CITY OF WORCESTER, MASSACHUSETTS

Shrewsbury Street Sewer Rehabilitation Sewer Rehabilitation Project  
Contract S24-1-ARPA  
Bid No. 8180-W4

ADDENDUM NO. 1

To be considered as part of the contract drawings and specifications for the Shrewsbury Street Sewer Rehabilitation Sewer Rehabilitation Project, dated April 2024:

**Shrewsbury Street Siphon Profile**

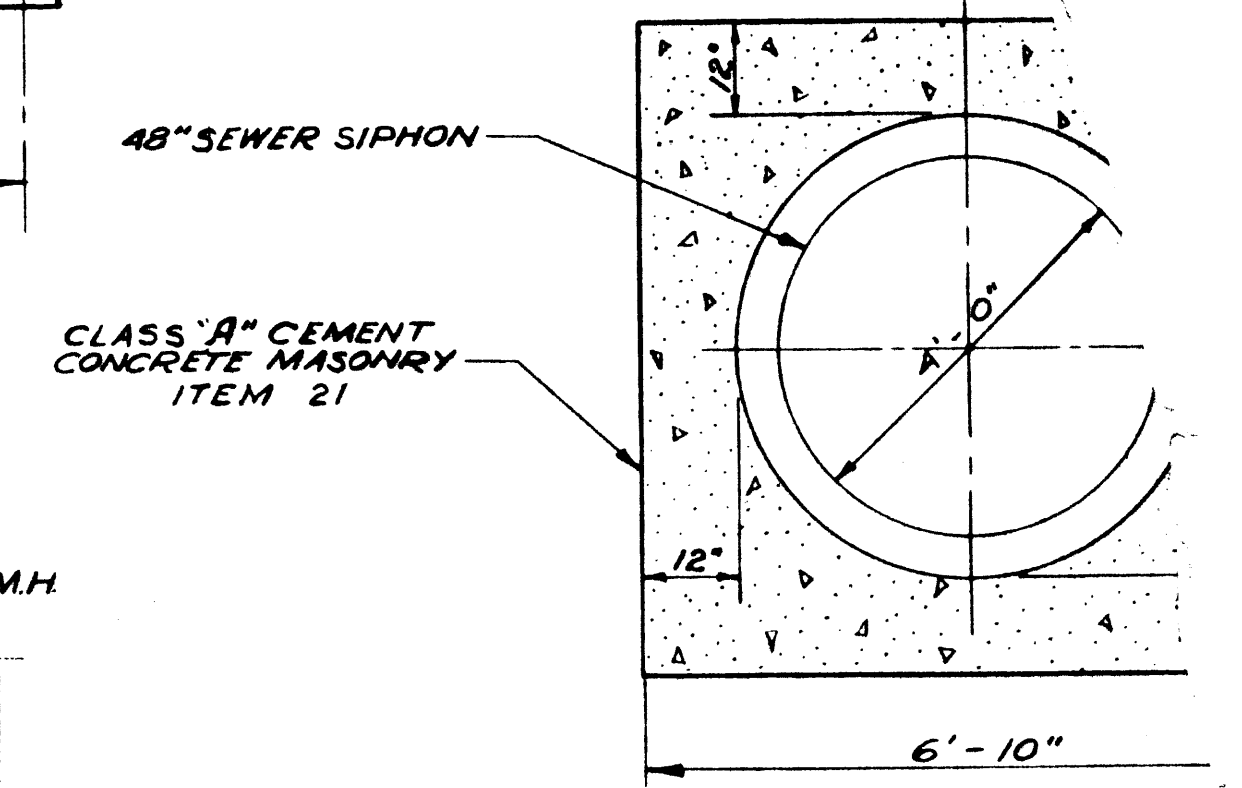
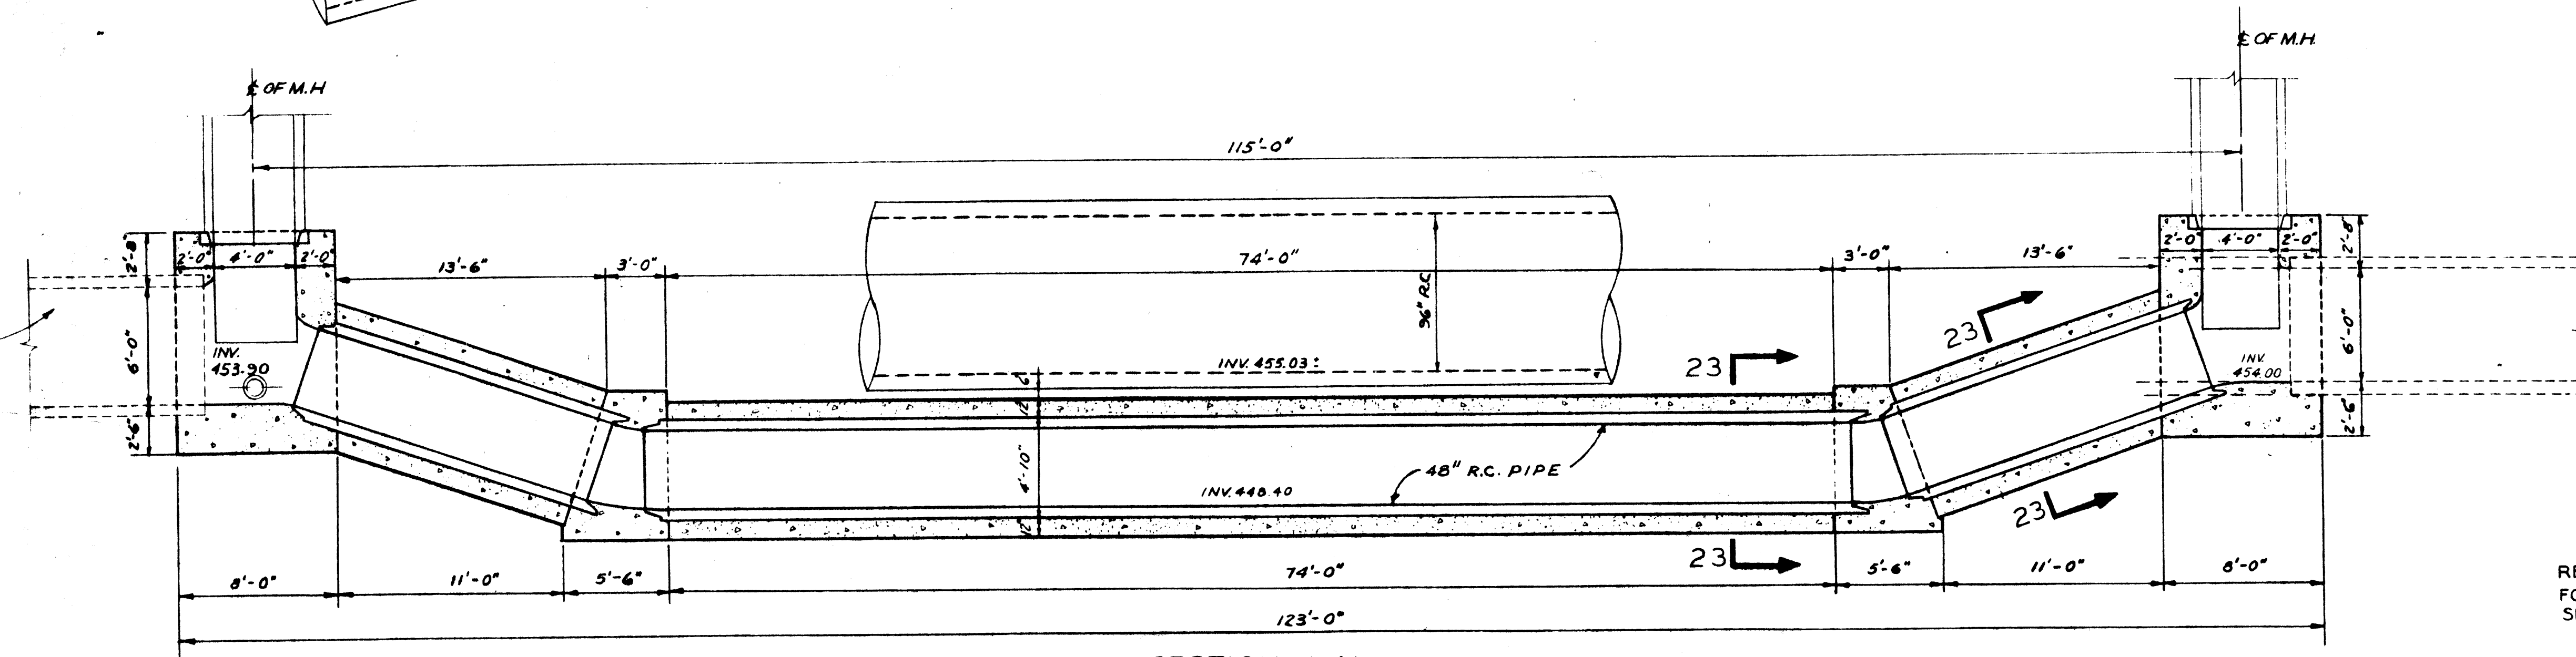
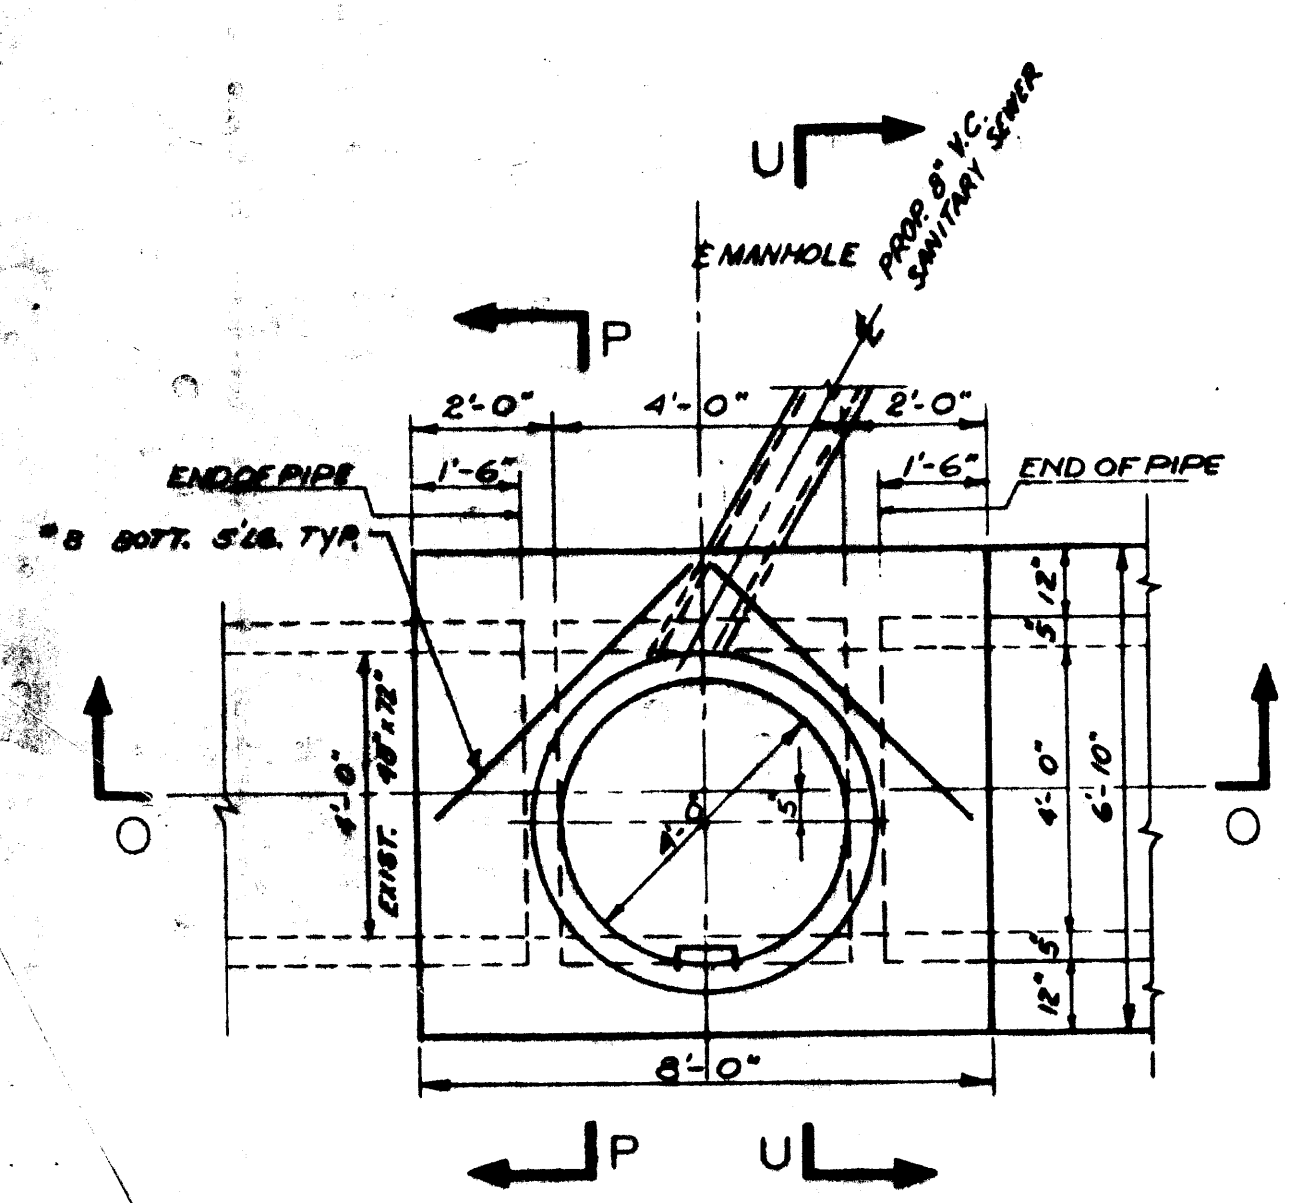
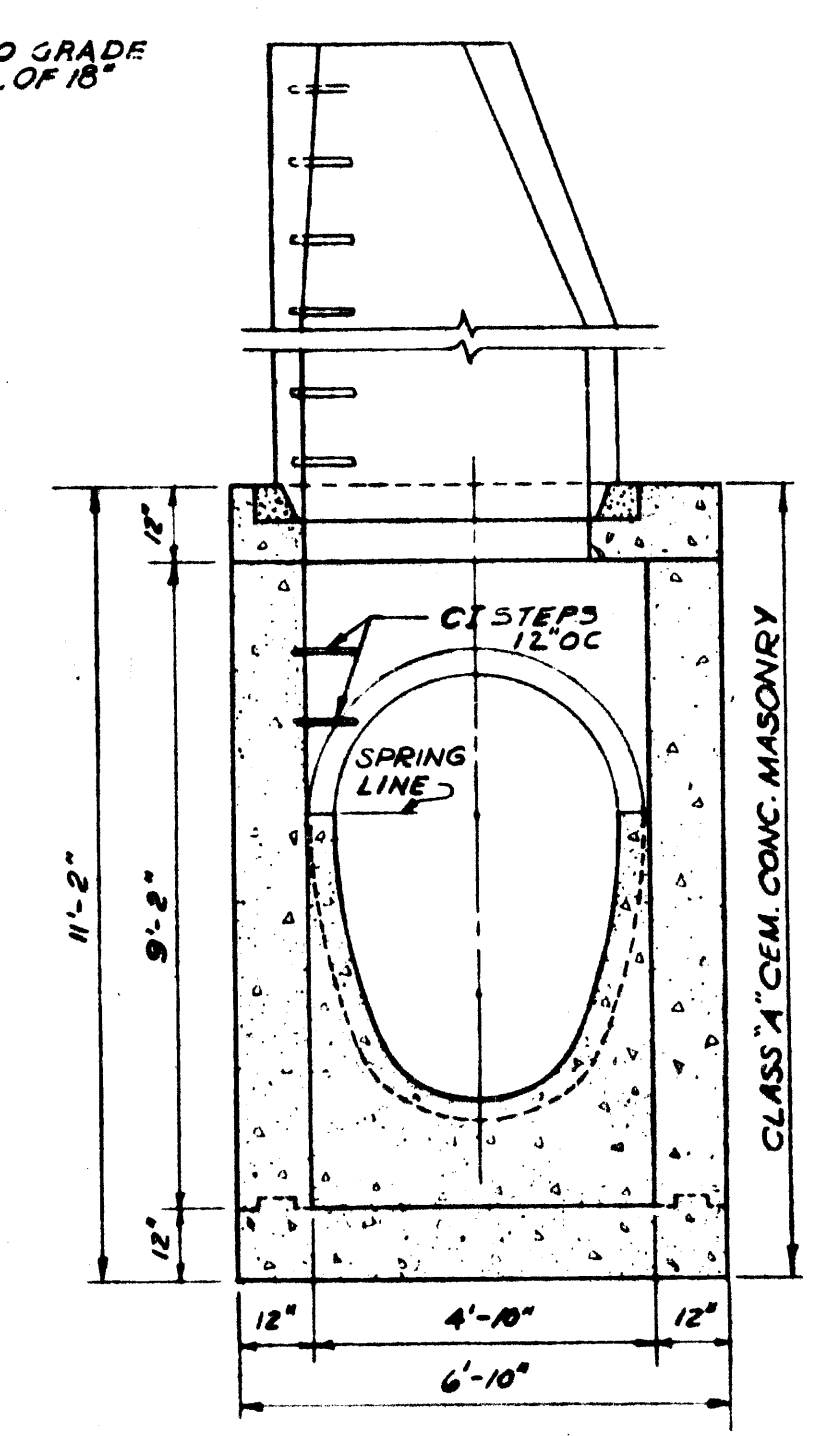
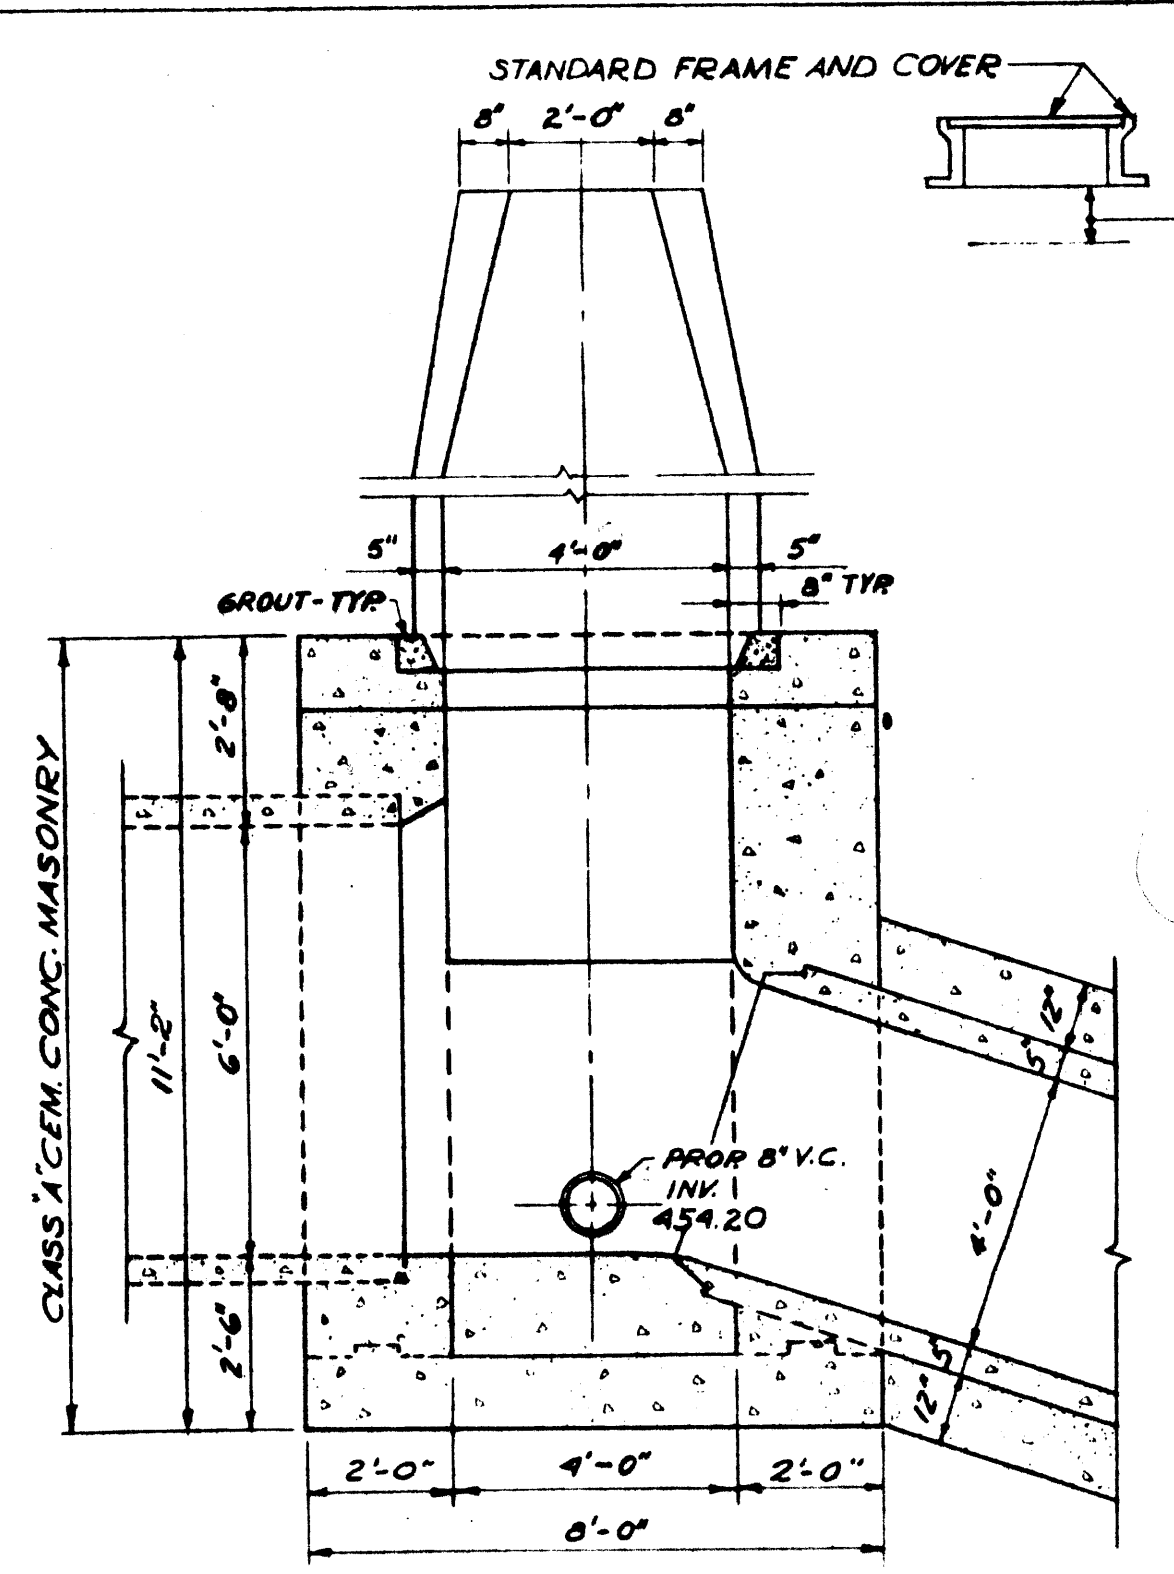
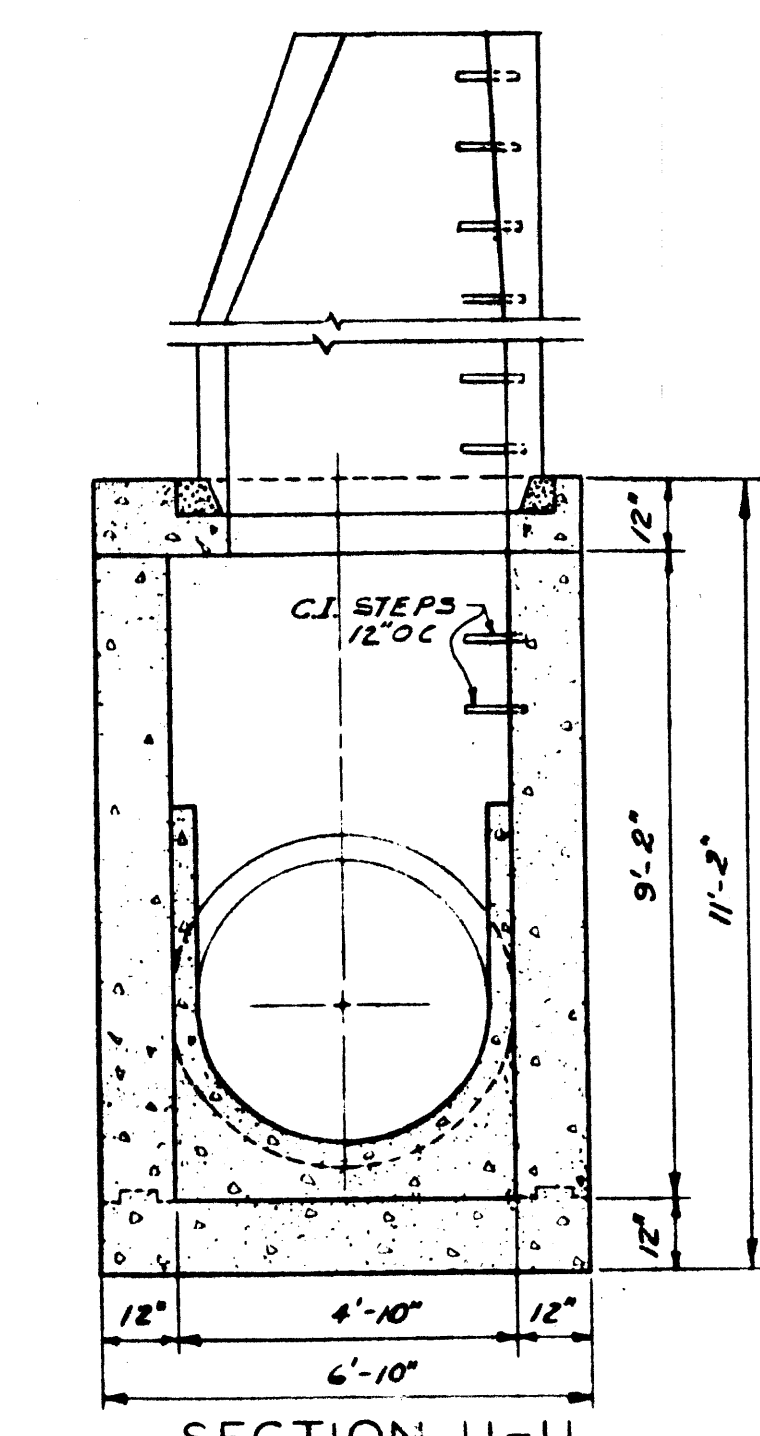
Q18. Please provide a profile of the siphon to be lined.

A18. **Profile of the siphon in the project area is attached as Attachment C.**
